#### **CITY PLAN COMMISSION**

**THURSDAY, MAY 4, 2023**

FILE NUMBER: S223-127 CHIEF PLANNER: Mohammad H. Bordbar

**REQUEST:** An application to replat a 0.186-acre (8,120 square feet) tract of land containing all of Lot 14 in City Block D/7247 to create one 6,120 square feet lot and one 2,000 square feet lot on property located on Pollard Street at Hearne Avenue, southwest corner.

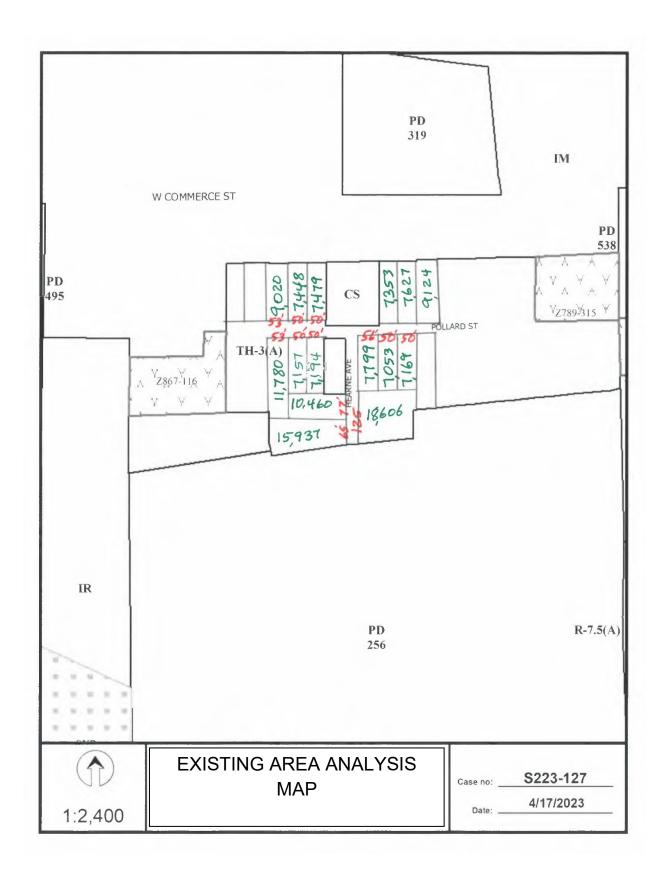
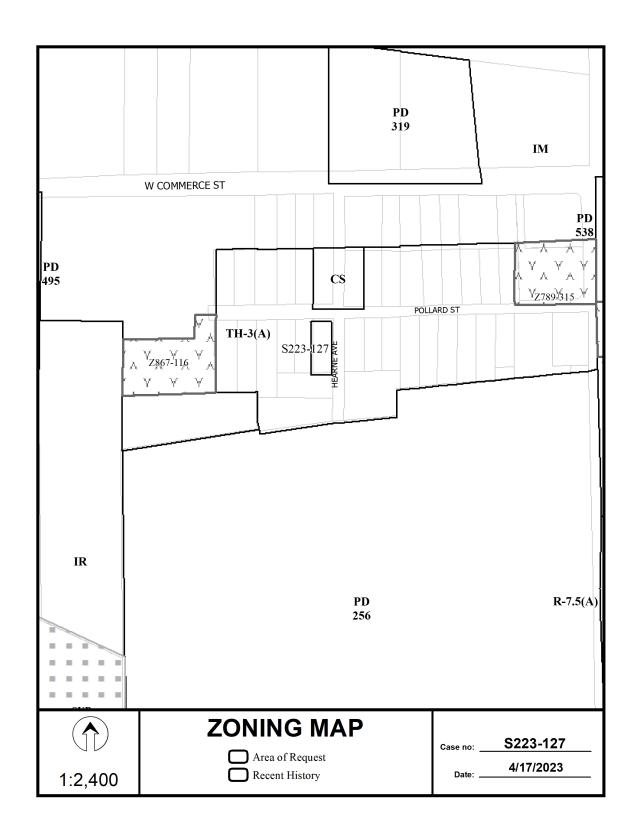
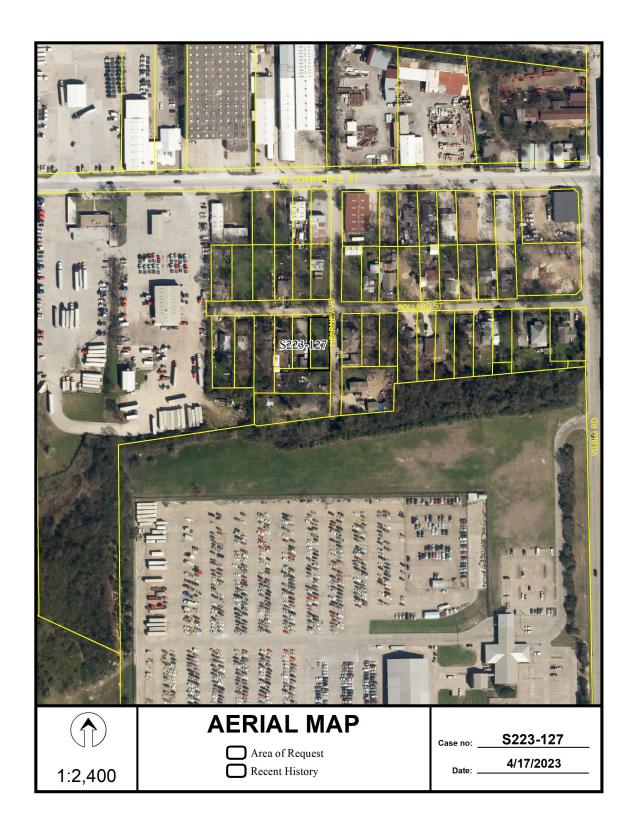
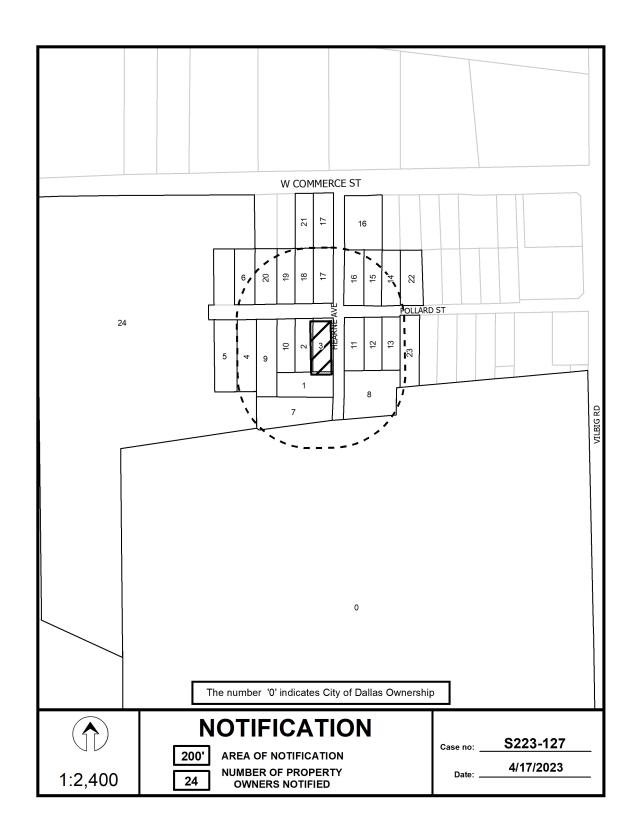
Staff finds there is a lot pattern in the immediate area of request and request complies with the requirements of TH-3(A) Townhouse District but does not comply with the requirement of Section 51A-8.503; therefore, staff recommends denial of the request; however, should the Commission approve the request, staff recommend that the approval be subject to compliance with the following conditions:

- 5. Any new or existing structure may not extend across new property lines. *Section* 51A-8.503(e)
- 6. On the final plat, all easement abandonments, and ROW abandonments must be by separate instrument with the recording information shown on the face of the plat. A release from the Real Estate Division is required prior to the plat being submitted to the Chairman for signature.

15. On the final plat, dedicate 28 feet of right-of-way (via fee simple or street easement) from the established centerline of Pollard Street Sections 51A-8.602(c), 51A-8.604(c) and 51A-8.611(c).

- 16. On the final plat, dedicate 28 feet of right-of-way (via fee simple or street easement) from the established centerline of Hearne Avenue Sections 51A-8.602(c), 51A-8.604(c) and 51A-8.611(c).
- 17. On the final plat, dedicate a minimum 5-foot by 5-foot corner clip (via fee simple or street easement) at the intersection of Pollard Street and Hearne Avenue Section 51A 8.602(d)(1)

- 18. Prior to final plat, submit a completed final plat checklist and all supporting documents.
- 19. On the final plat, add/show Lien Holders Subordination Agreement. Platting Guidelines.
- 20. On the final plat, chose a new or different addition name. Platting Guidelines.
- 21. Prior to final plat, provide one legal description of overall boundary.

22. Additional design information is required for assessment. Site plan must be submitted showing proposed development, building finished floor elevation, development, existing mains – including downstream manhole, and proposed water and wastewater service locations. Submit water/wastewater engineering plans to 320 E. Jefferson Blvd., Room 200, Attention: Water and Wastewater Engineering.

- 23. Prior to final plat, provide evidence to Real Estate Department that fencing is no longer in the right-of-way of Hearne Avenue.
- 24. On the final plat, identify the property as Lots 14A and 14B in City Block D/7247. Ordinance 1A, Page 131 pages 131-148, Section 2 (passed August 13, 1872).
